SUBJECT: Documentation of Review Findings, Craney Island Eastward Expansion, Final Feasibility Report and Environmental Impact Statement dated April 2006 (revised August 2006).

**DOCUMENTATION OF REVIEW FINDINGS  
FINAL FEASIBILITY REPORT AND FINAL ENVIRONMENTAL IMPACT  
STATEMENT  
NORFOLK HARBOR AND CHANNELS  
HAMPTON ROADS, VIRGINIA  
CRANEY ISLAND EASTWARD EXPANSION  
APRIL 2006 (revised 11 August 2006)**

Figure 1 - Layout of New Cell

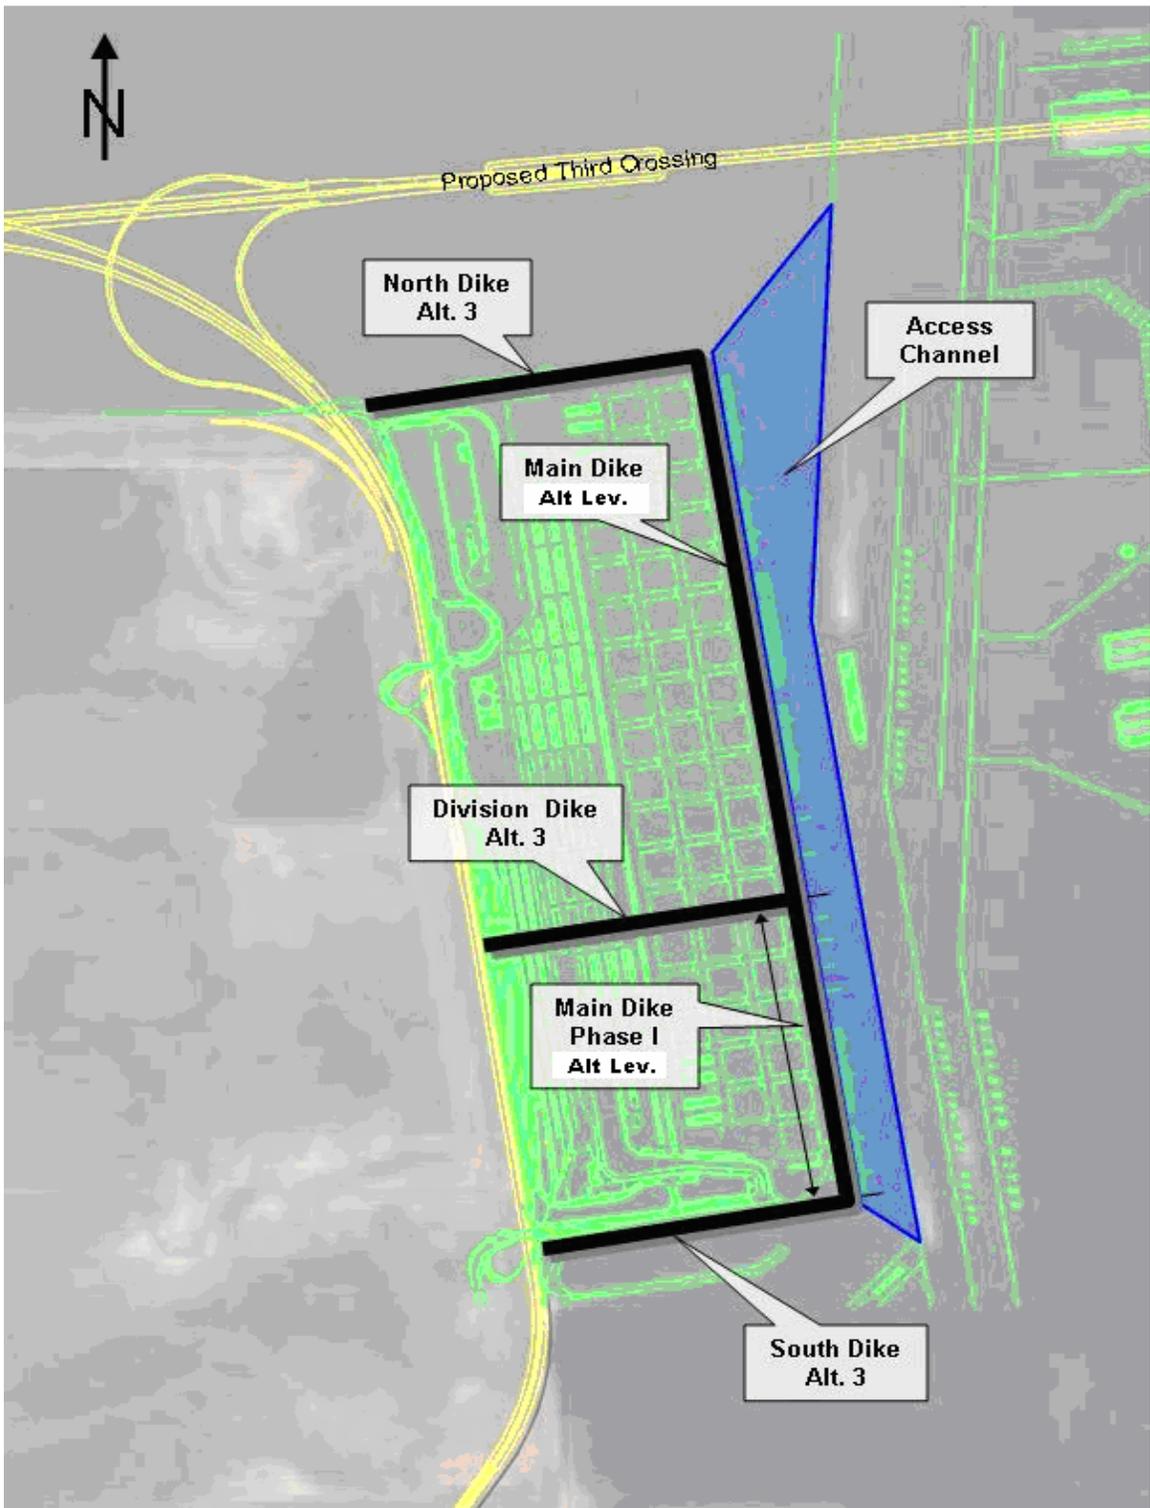
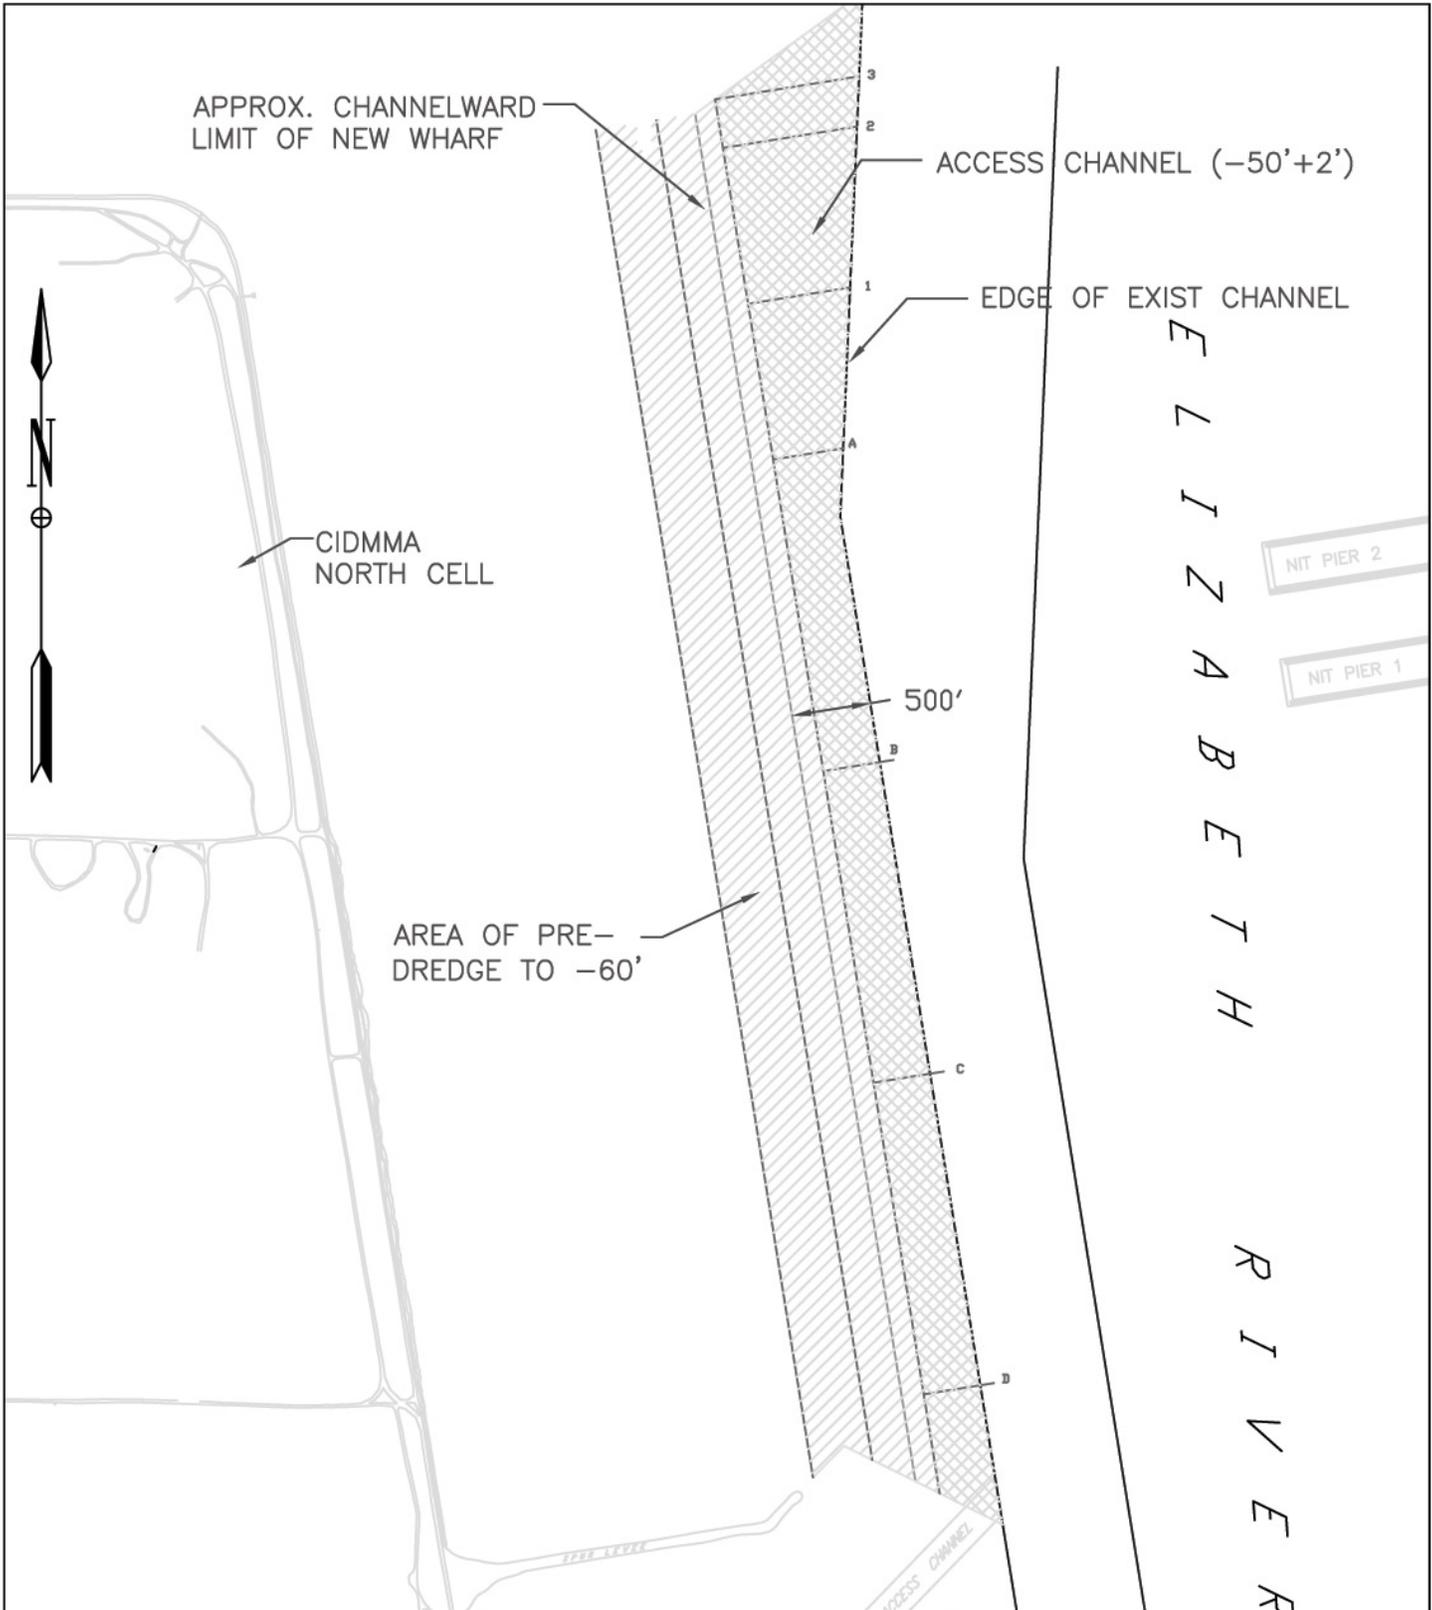
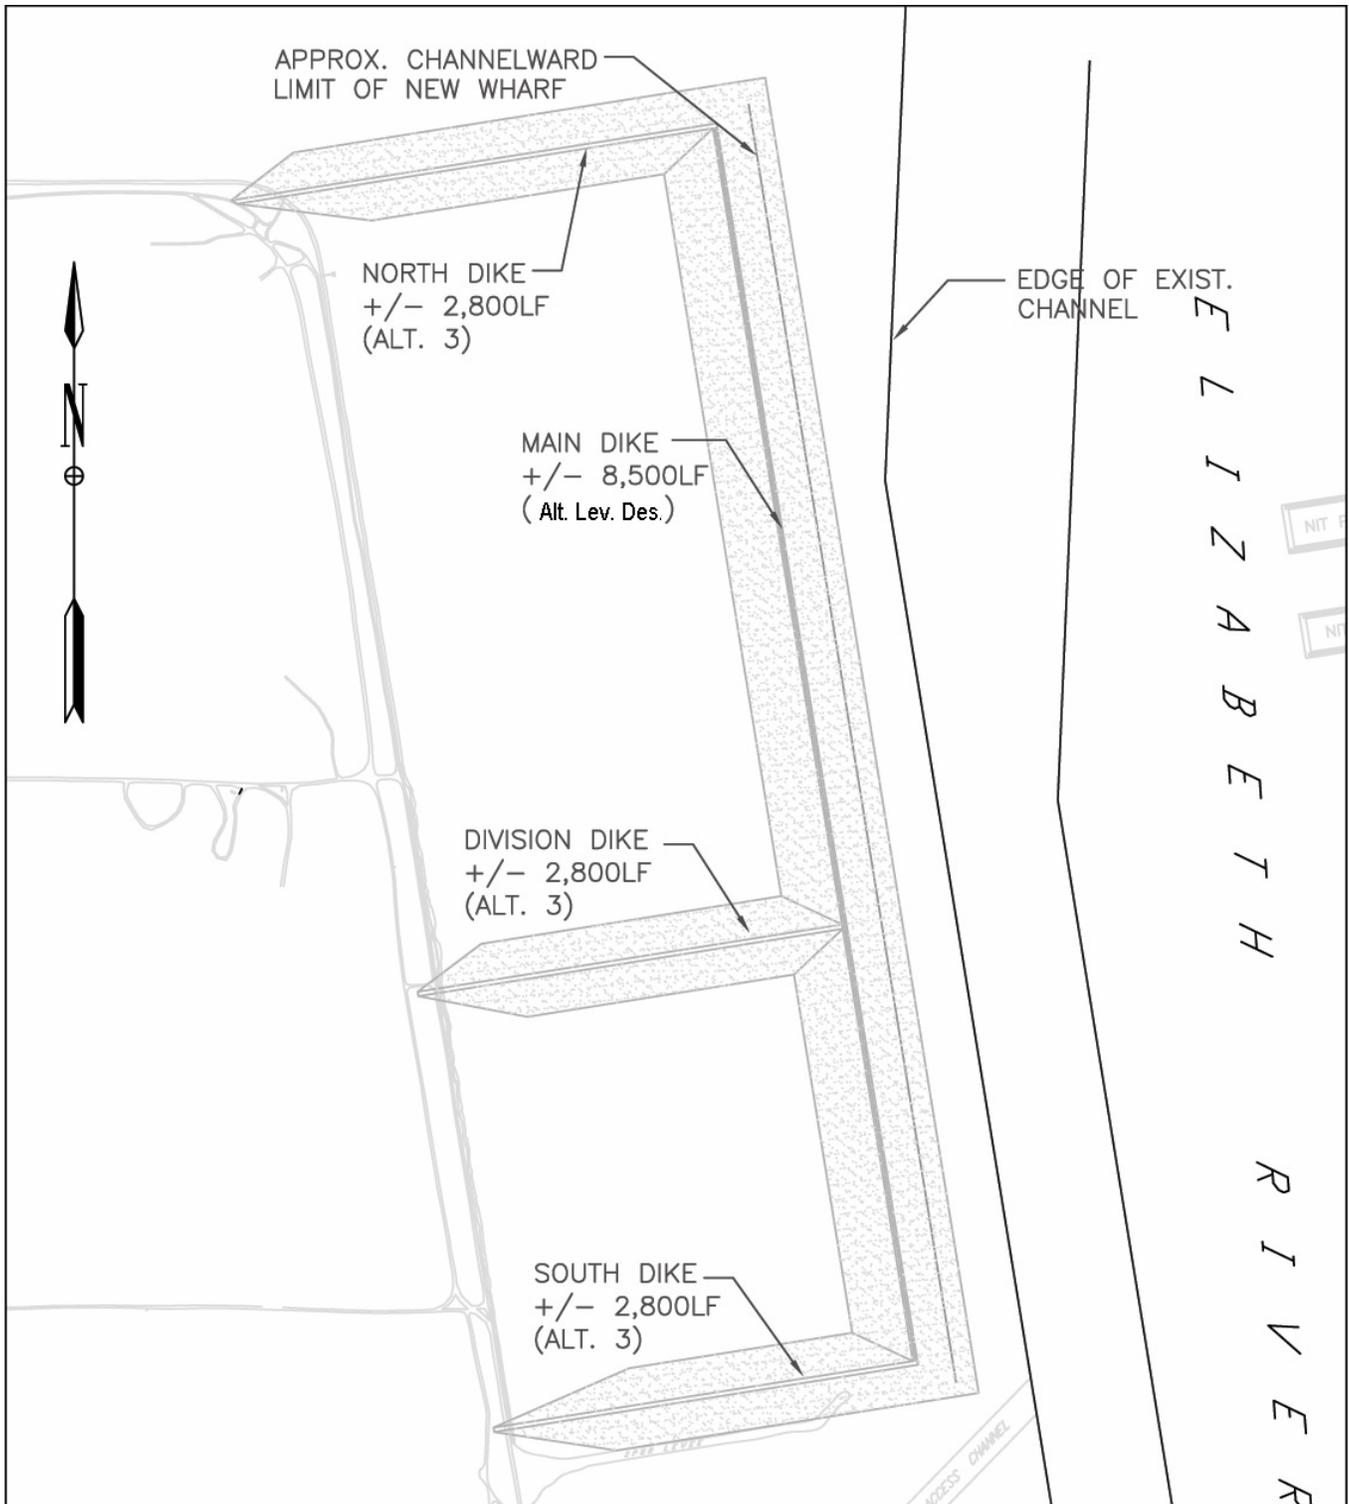
1. Sand Fill. In order to construct the dikes, sand will be dredged from offshore borrow areas by hopper dredge. Once transported to the eastward expansion site the material will be offloaded using a self-contained offshore transfer station buoy ("SCOTS buoy"). The Atlantic Ocean Channel is designated as the primary source of material for dike construction. NEPA documentation will name the Atlantic Ocean Channel as the primary borrow source for dike construction, with Thimble Shoal and Cape Henry Channels as secondary sources. Sketch 2 shows dike layout. Sketches 3 and 4 show dike geometry for the two dike geometries (Alternative 3 and Alternative Levee Design).

**Action Taken:** The draft report contains a more comprehensive explanation of project design, construction methods, and costs as directed. This is located on page 88-93.
